City of Miami

ADDENDUM No. 2

Invitation to Bid No. 18-19-007-R

BAYSIDE WHARF MIAMARINA – PIER 5 (NORTH SECTION)

S:\Coastal Systems International\MiaMarina\Electrical\17041-E-3.0-Demo Electrical Site Plan.dwg

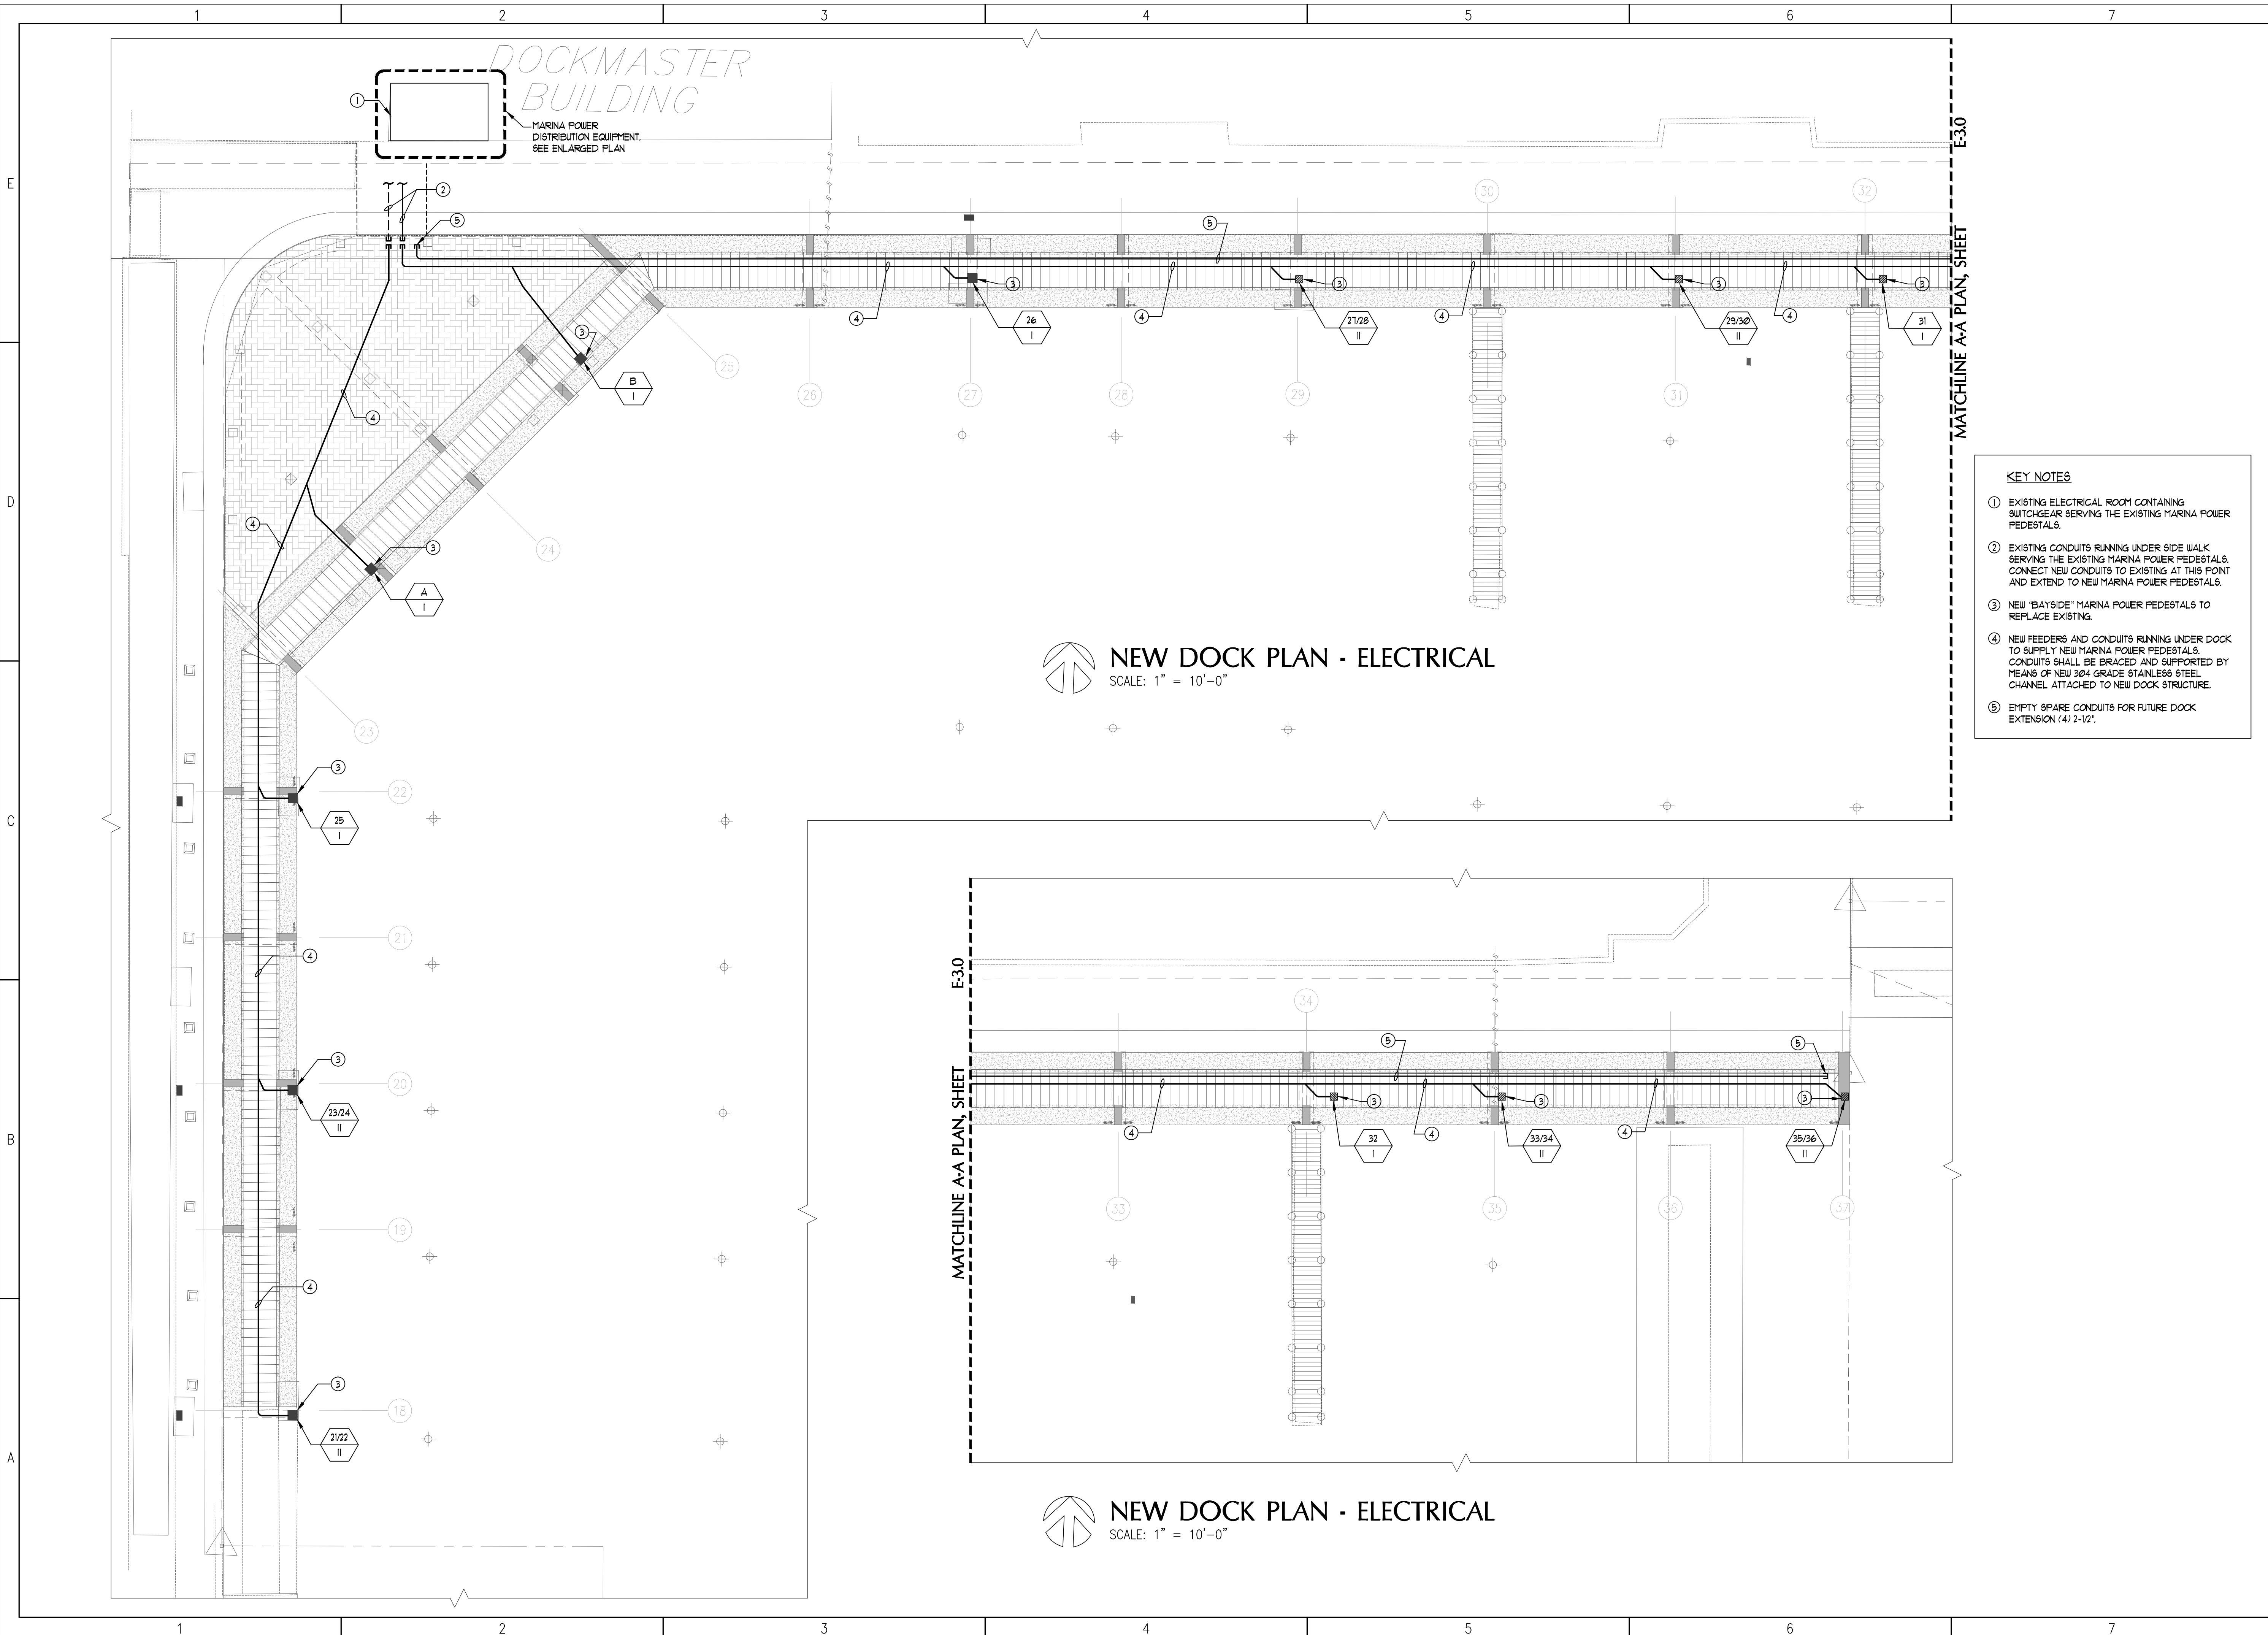
Q11. Who will be responsible to relocate the existing electrical duct bank? Please provide drawings for this work.

Q12. Please revise the electrical drawings to reflect the as-built conditions.

A11. The Contractor will be responsible for relocating the existing duct bank. Please see the Plans attached to this Addendum.

A12. Please see the Plans attached to this Addendum.
